COPPER GATE ADDITION

Re: S/D 98-41 -- One-Step Final Plat of COPPER GATE ADDITION

STAFF REPORT
(One-Step Final Plat-Approved 05/07/98)

CASE NUMBER: S/D 98-41 - COPPER GATE ADDITION
OWNER/APPLICANT: John Dugan, 2416 Morning Dew, Wichita, KS 67205
SURVEYOR/ENGINEER: Baughman Company, P.A., 315 Ellis, Wichita, KS 67211
LOCATION: Northwest and southwest corner of 13th St. North and 135th St. West

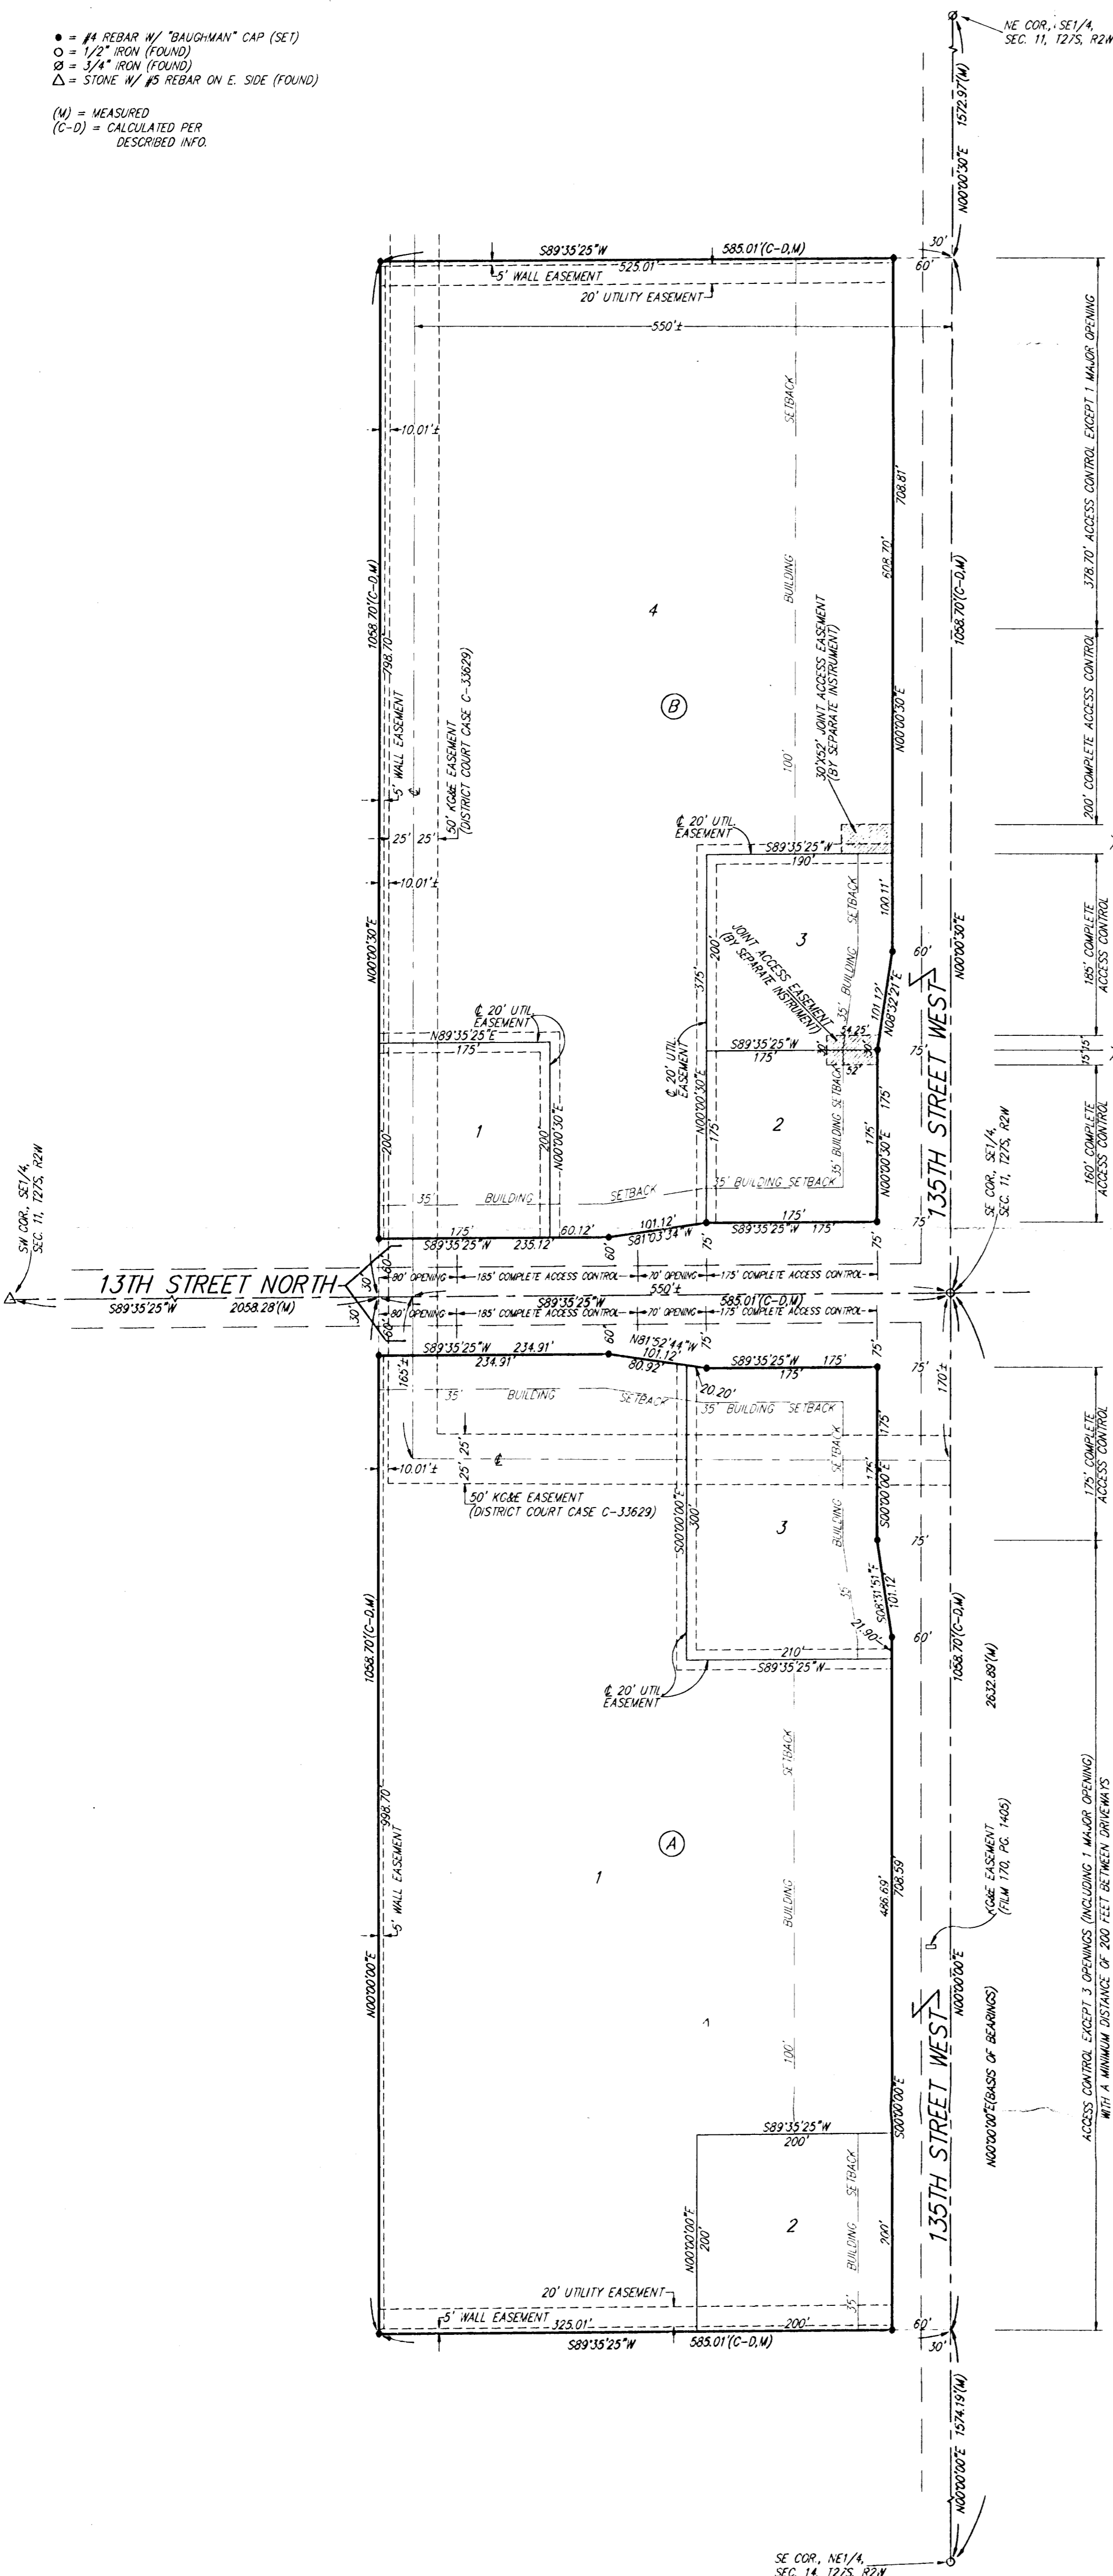
- D. **Regarding the southern tract, Traffic Engineering requires 160 feet of complete access control along the eastern boundary of Lot 3. The three permitted openings along 135th St. must be separated by a minimum of 200 feet. Along 13th St. North, two joint openings along the northern tract will line up north and south with openings along the southern tract. There shall be 175 feet of critical access control on both the north and south sides of 13th Street, from 135th Street West. Critical Access Control should be provided from a point 243 feet west of 135th Street to a point 431 feet west of 135th Street.**

In regards to the northern tract, the plat denotes three openings along 135th St. West - two openings for lot 4, and a joint access between lots 2 and 3, in accordance with the CUP. Cross-lot access agreements and a CUP adjustment will be needed if this revision is approved.

- A. **City Engineering** needs to indicate the need for guarantees or easements. **Guarantees for future sewer and water extension will be needed. Per the CUP, the site cannot be developed until municipal water and sanitary sewer are available.**

- C. **County Engineering** needs to comment on the status of the applicant's drainage plan. **The drainage plan needs to be approved.**
- D. **Traffic Engineering** needs to comment on the acceptability of the access controls. In regards to the southern tract, the plat denotes three openings along 135th St. West - a joint opening between lots 1 and 2, one opening for lot 1, and one opening for lot 3 in accordance with the CUP. Also for the southern tract, the plat denotes two openings along 13th St. North, both located within lot 1 and complete access control along lot 3; whereas the CUP permitted one opening for lots 1 and 3. A CUP adjustment will be needed if this revision is approved. **Regarding the southern tract, Traffic Engineering requires 175 feet of complete access control along the eastern boundary of Lot 3. The three permitted openings along 135th St. must be separated by a minimum of 200 feet. Along 13th St. North, two joint openings along the northern tract (between Lots 1 and 4, and between lots 4 and 2) will line up north and south with openings along the southern tract.**

In regards to the northern tract, the plat denotes three openings along 135th St. West - two openings for lot 4, and a joint access between lots 2 and 3, in accordance with the CUP. Also for the northern tract, the plat denotes two openings along 13th St. North for Lot 4,

with complete access control along lots 1 and 2; whereas the CUP required both of these openings to be joint accesses. Cross-lot access agreements and a CUP adjustment will be needed if this revision is approved.

- P. The representatives from the utility companies should be prepared to comment on the need for any additional utility easements to be platted on this property. **Southwestern Bell requests additional easements.**
